Certificate of Appropriateness For a Building Permit

Administrative Review

File No.: 8-A-22-TOA

1) The applicant is requesting approval of a revised set of plans for an office warehouse facility on a 7.99-acre site accessed off of Horseshoe Bend Lane, a local road. Site plans were approved in March 2021 (Case 3-B-21-TOB). The proposed revisions are minor and can be approved administratively by staff.

SHEET NO.
C2.0

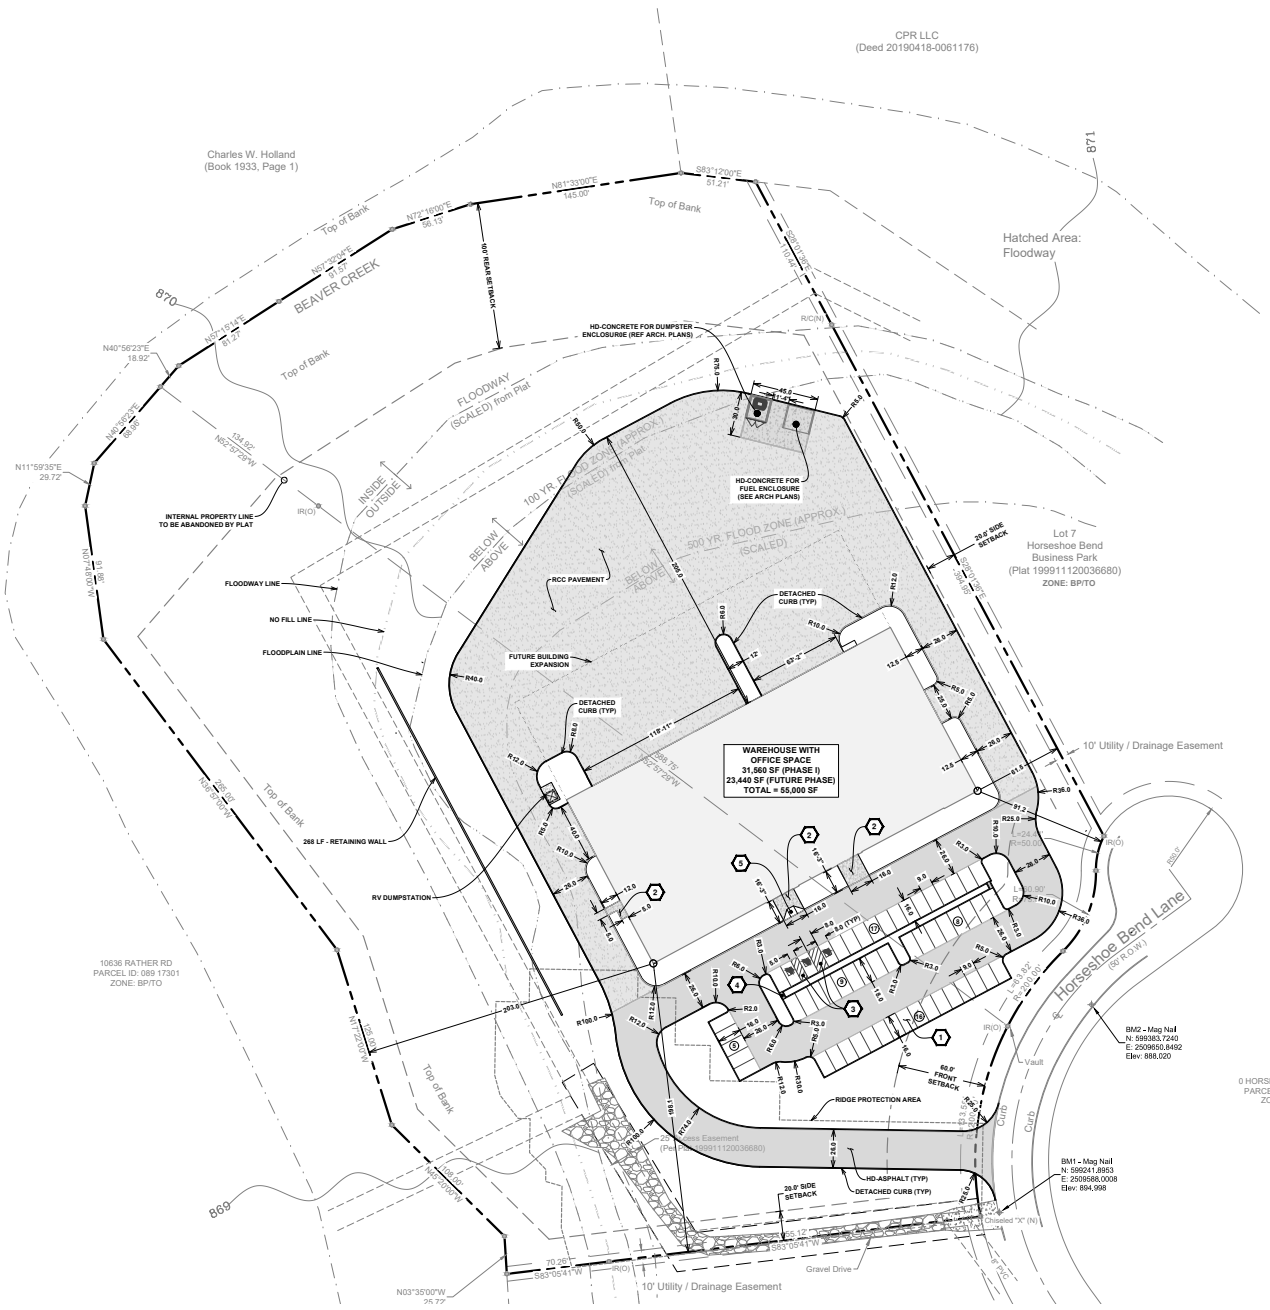
b. Redistribution of rolling dock doors – the previous plans included a total of 10 dock doors, and the revised plans also include a total of 10. However, these have been redistributed among the side and rear facades increasing the dock doors on the rear façade by 2 and reducing the dock doors on the east and west (side) façades by 1 each.

c. Installation of a single driveway instead of two driveways, further reducing the IAR.
d. Slight change in the number of parking spaces, going from 56 spaces approved to 55 spaces proposed now.

e. Slight alteration of plantings to accommodate the driveway changes. The rest of the landscaping plan remains unchanged.
f. The fuel island that was approved in the original plans has been moved nearer the dumpster.

2 ELECTRICAL - SITE PLAN PHOTOMETRICS
1" = 40'-0"

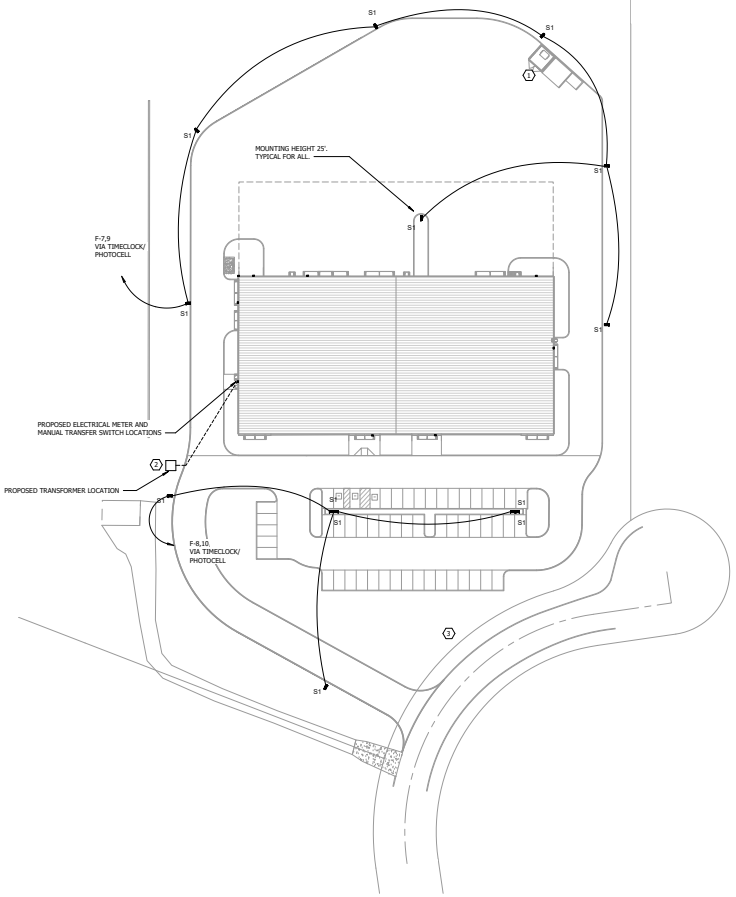
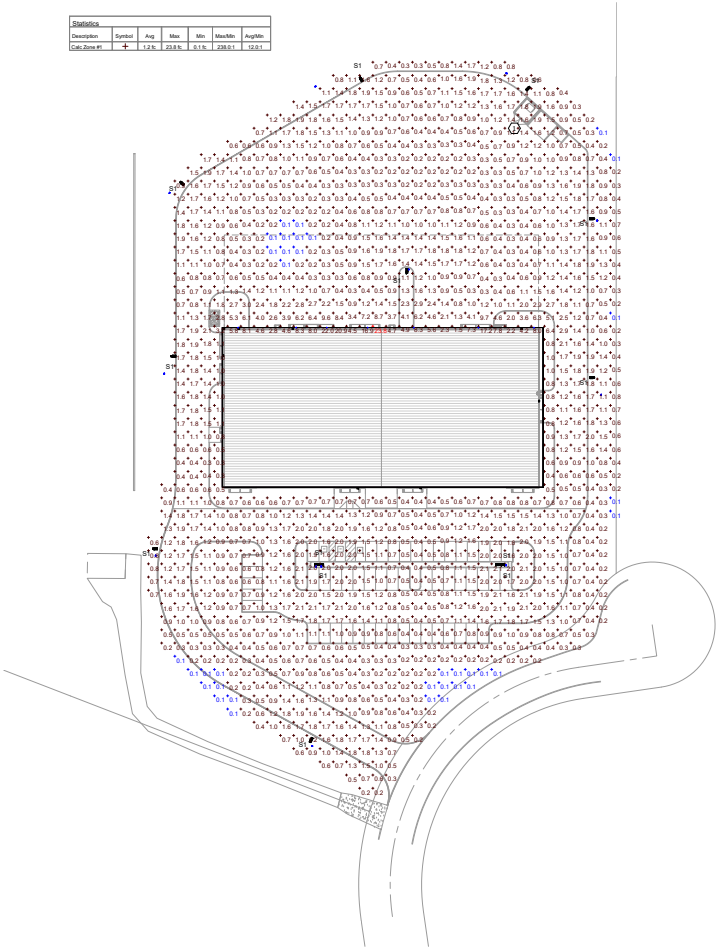
The waivers approved in March 2021 (3-C-21-TOB) would still be applicable, but they are no longer required. The lighting plan has been revised and is now in compliance with TTCDA Guidelines, the foundation landscaping is more than 50% of the front and side facades, and the previously approved metal panels are discouraged, not prohibited.

building facade. Typically, approved waivers would still be applicable for a revised set of plans, but in this case, they are no longer required. The lighting plan has been revised and is now in compliance with TTCDA Guidelines, the foundation landscaping is more than 50% of the front and side facades, and the previously approved metal panels are discouraged, not prohibited, and are mitigated with the foundation plantings.
